SITE AS-BUILT LIMITED SITE PLAN MODIFICATION
76 GROVE STREET (LOT 3)
FRANKLIN, MASSACHUSETTS

In response to the applicant's submission of a final Form H for the subject project, we reviewed the final as-built plan, the approved Limited Site Plan Modification from 2008, and performed a site visit. We offer the following comments:

Observed Construction: BETA arrived on-site to perform a conformance observation in conjunction with the Applicant’s for acceptance Form H – Certificate of Completion. The as-built plan, dated June 8, 2022, and Form H were provided by email. BETA walked the site and noted that the project has been constructed in general accordance with the approved plans with the following exceptions/notations:

Date: 7/20/2022 Job No.: 4831-106
To: Mr. Gregory Rondeau, Chairman
Cc:
From: BETA Group, Inc.
Subject: Washington Street (Franklin Flex Space) Field Modification

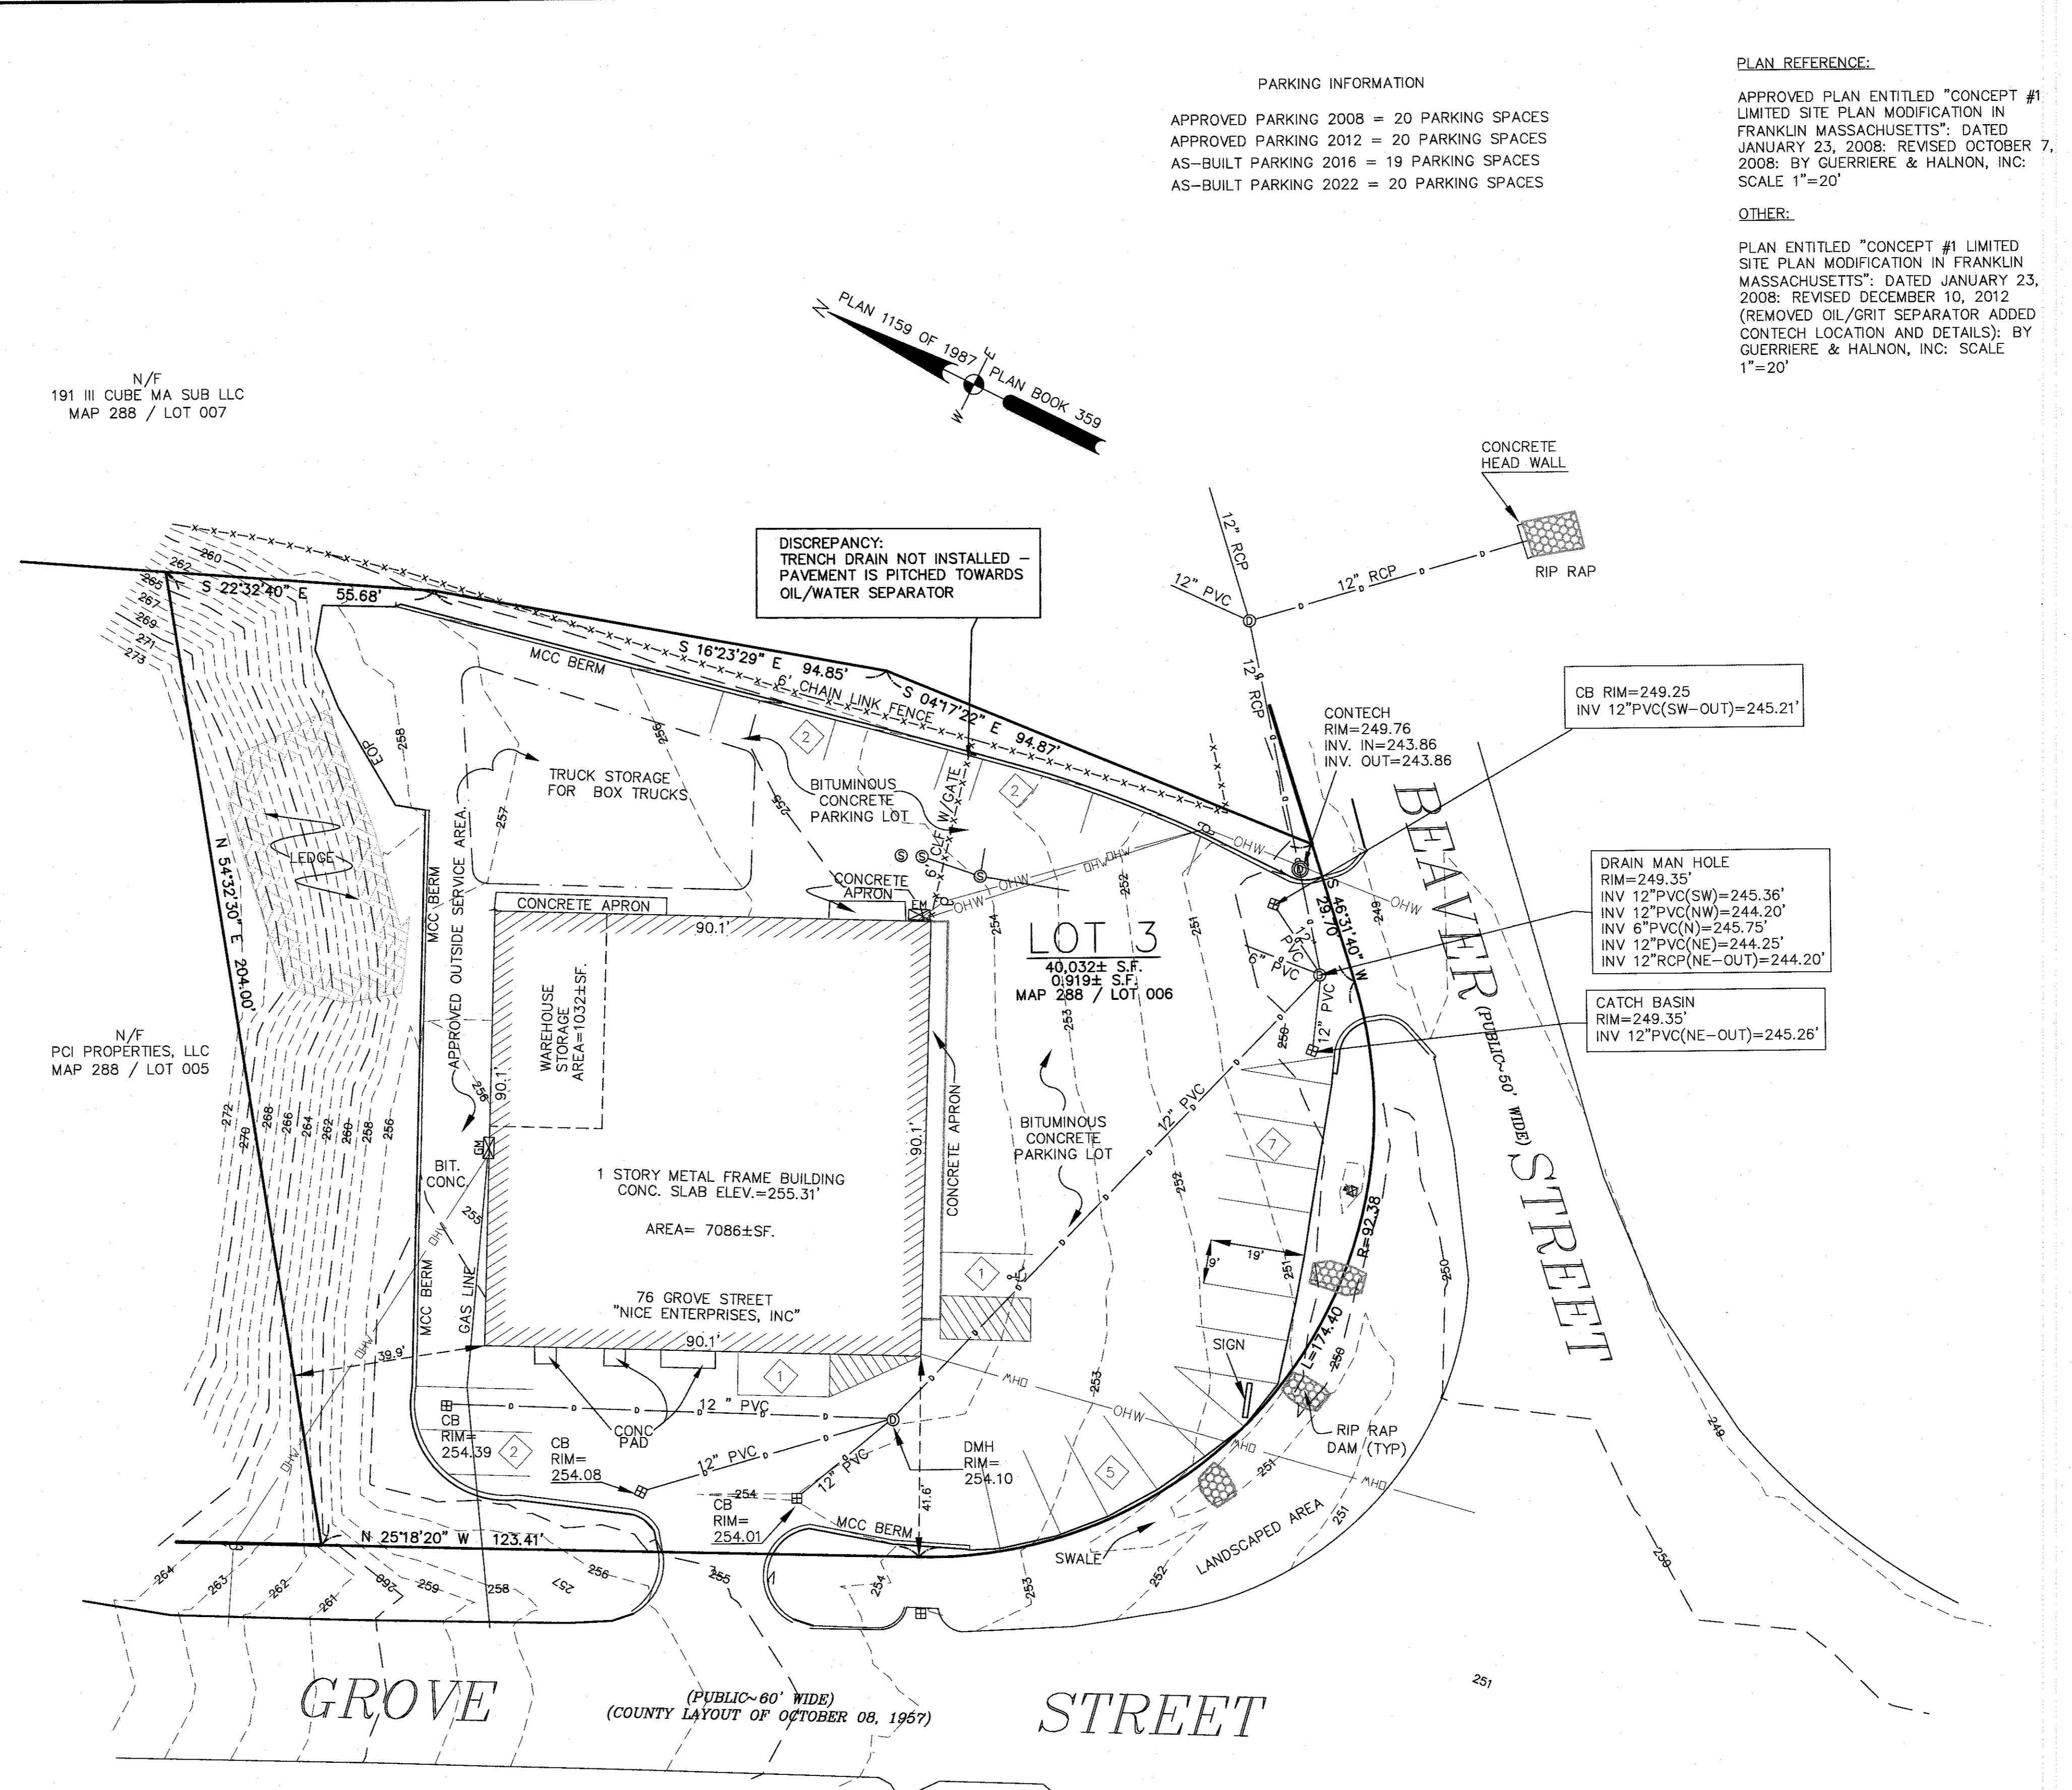
1. As noted on the as-built plan, the proposed trench drain at the corner of the building was not installed, but rather the pavement was graded to the two catch basins at the entrance on Beaver St. The two catch basins at this location are set low with a slight hump in the driveway apron and while we haven't had the opportunity to witness them in a heavy rain, they appear to be effective.
2. The proposed oil/grit separator was not installed downstream of the trench drain as shown on the plan, however a water quality manhole was installed downstream of all the site catch basins which is providing water quality treatment for a larger portion of the site.
3. The proposed plan called out for the removal of 786+/- sf of pavement from the rear of the site which was to be replaced with 12" to 18" of crushed stone, however the existing asphalt has not been removed.
